HISTORIC AND DESIGN REVIEW COMMISSION

HDRC CASE NO: 2021-113
ADDRESS: 101 PASO HONDO
LEGAL DESCRIPTION: NCB 591 BLK 4 LOT 13
ZONING: RM-4, H
CITY COUNCIL DIST.: 2
DISTRICT: Dignowity Hill Historic District
APPLICANT: George Torres/George Torres Architect
OWNER: Brett Cohen/JRB CAPITAL LLC
TYPE OF WORK: Construction of 4 residential structures
APPLICATION RECEIVED: March 01, 2021
60-DAY REVIEW: Not applicable due to City Council Emergency Orders
CASE MANAGER: Edward Hall

Historic and Design Review Commission
Design Review Committee Report

UNIT 1
FIRST FLOOR PLAN
3/16" = 1'-0"

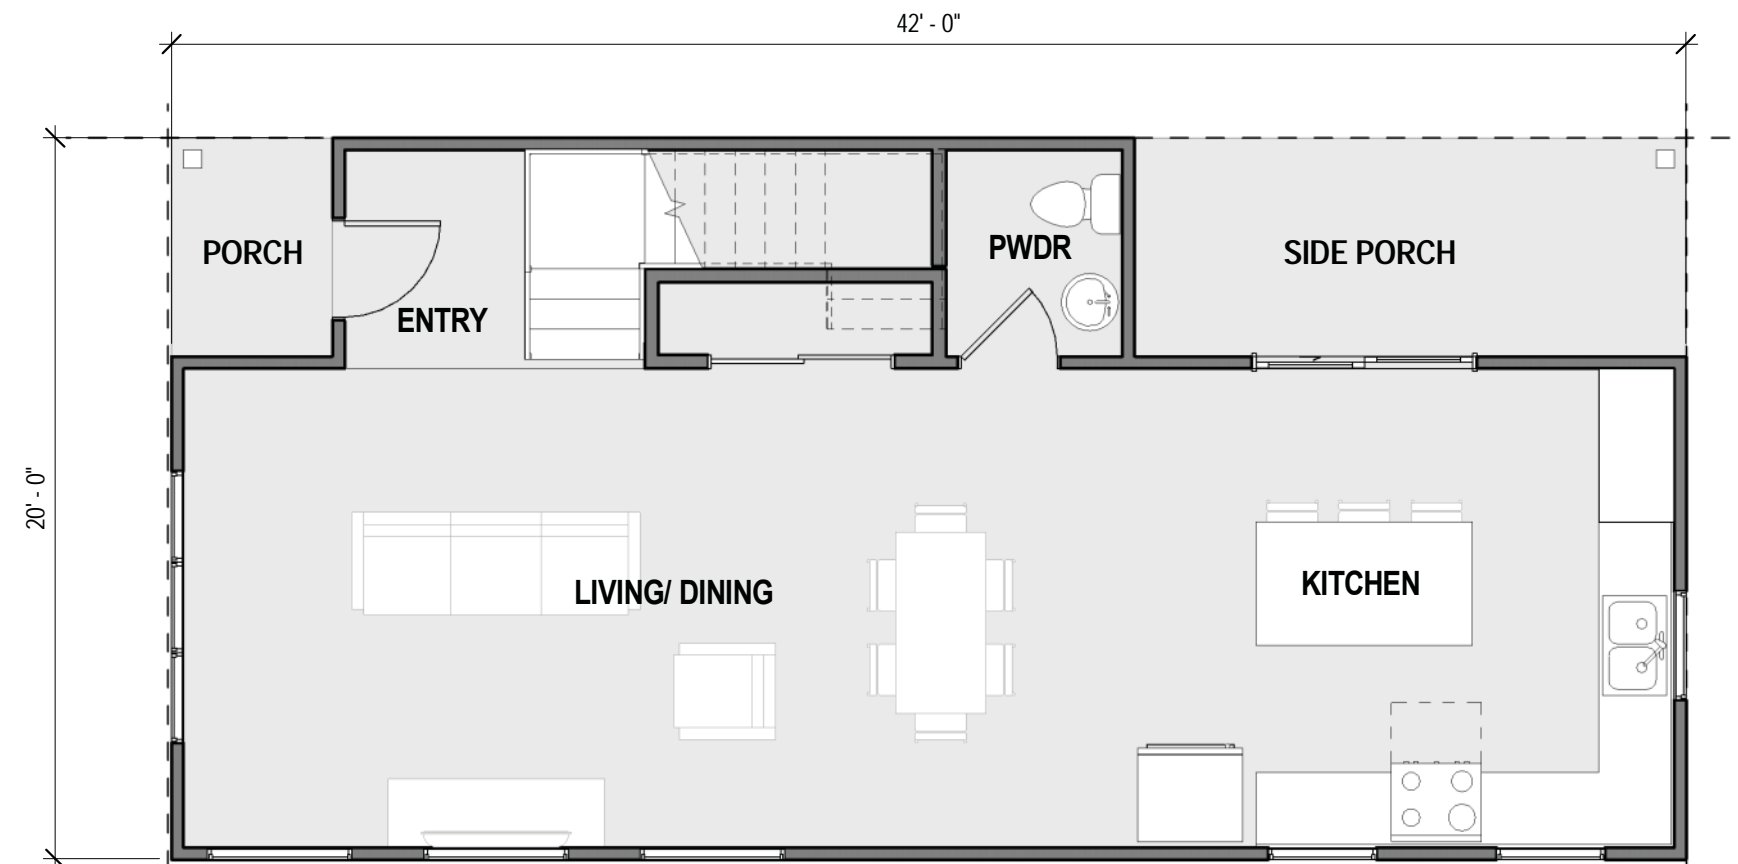
- d. **SETBACKS & ORIENTATION** – The applicant has proposed four structures on the vacant lot at 101 Paso Hondo. Three of the four structures is to feature an orientation toward N Mesquite, with the proposed front elevation of unit 1 being oriented toward Paso Hondo. Per the Guidelines for New Construction 1.A.i, the front façade of new buildings should be oriented to be consistent with the predominant orientation of historic buildings along the street frontage. Generally, staff finds the proposed setback on Paso Hondo to be appropriate; however, staff finds that the façade facing Paso Hondo should further rear as a front façade; in architectural details and massing.

- g. **FOUNDATION & FLOOR HEIGHTS** – Per the Guidelines for New Construction 2.A.iii., applicants should align foundation and floor-to-floor heights within one foot of floor-to-floor heights on adjacent historic structures. Per the submitted construction documents, the applicant has proposed foundation heights of less than one foot. Staff finds that the applicant should utilize foundation heights that are consistent with the Guidelines, at least one (1) foot in height.

- i. WINDOW & DOOR OPENINGS – Per the Guidelines for New Construction 2.C.i., window and door openings with similar proportions of wall to window space as typical with nearby historic facades should be incorporated into new construction. The applicant has proposed window and door openings that are both consistent and inconsistent with the Guidelines. Staff finds that contemporarily sized windows, including rectangular and fixed windows, as well as those that do not feature separating mullions should be eliminated and that windows that are comparable to those found historically within the district be imported into the design.

- j. PORCHES – Within the Dignowity Hill Historic District, porches historically are integrated into the massing of the historic structure, often sharing a roof form with the primary massing of the structure. The applicant has proposed porches that are one story stoops with flat roofs. The proposed porch design is atypical for what is found historically within the district. Staff finds that the applicant should increase massing and detail for the proposed porches. Additionally, staff finds that each porch should feature a depth of at least five (5) feet.

- i. That the develop a front façade that features details and massing consistent with front facades found on this block of Paso Hondo, as noted in finding d.

- iv. that the applicant should utilize foundation heights that are consistent with the Guidelines, at least one (1) foot in height, as noted in finding g.

- v. That contemporarily sized windows, including rectangular and fixed windows, as well as those that do not feature separating mullions be eliminated and that windows that are comparable to those found historically within the district be imported into the design, as noted in finding i.

- vi. That the applicant increase porch massing and detail and that each porch should feature a depth of at least five (5) feet. Porch massing should be integral into the massing of the proposed new construction.

PROPOSED MATERIALS

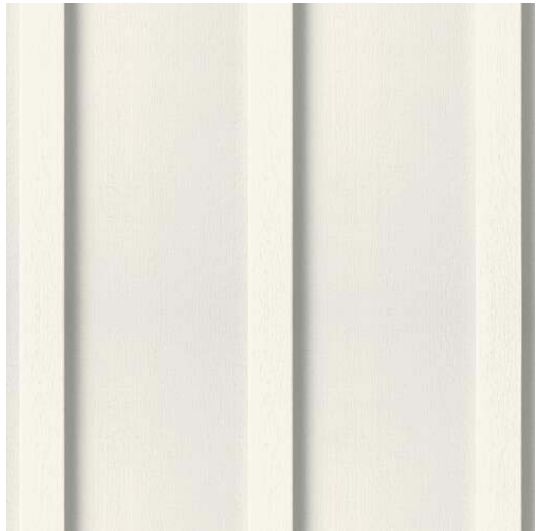
- l. MATERIALS – The applicant has noted the installation of standing seam metal roofs, composite siding, steel entry doors, and board and batten siding. Staff finds that all standing seam metal roof should feature seams that are 1 to 2 inches in height, panels that are smooth and 18 to 21 inches in width, a standard galvalume finish, and a crimped ridge seam or low profile ridge cap. Additionally, staff finds that all horizontal siding should feature smooth panels with a four inch exposure and a thickness of $\frac{3}{4}$ of an inch. Regarding board and batten siding, staff finds that all boards should be 12 inches in width with battens that are approximately 1.5 inches in width. Smooth composite siding should be used throughout.

- m. WINDOW MATERIALS – The applicant has noted the installation of aluminum clad wood windows. Staff finds that product specifications should be submitted to staff for review and approval that are consistent with staff's standard specifications for windows in new construction.

- vii. That all standing seam metal roof should feature seams that are 1 to 2 inches in height, panels that are smooth and 18 to 21 inches in width, a standard galvalume finish, and a crimped ridge seam or low profile ridge cap. Additionally, staff finds that all horizontal siding should feature smooth panels with a four inch exposure and a thickness of $\frac{3}{4}$ of an inch. Regarding board and batten siding, staff finds that all boards should be 12 inches in width with battens that are approximately 1.5 inches in width. Smooth composite siding should be used throughout.

- viii. That wood or aluminum clad wood windows be used, and that product specifications be submitted to staff for review and approval that are consistent with staff's standard specifications for windows in new construction.
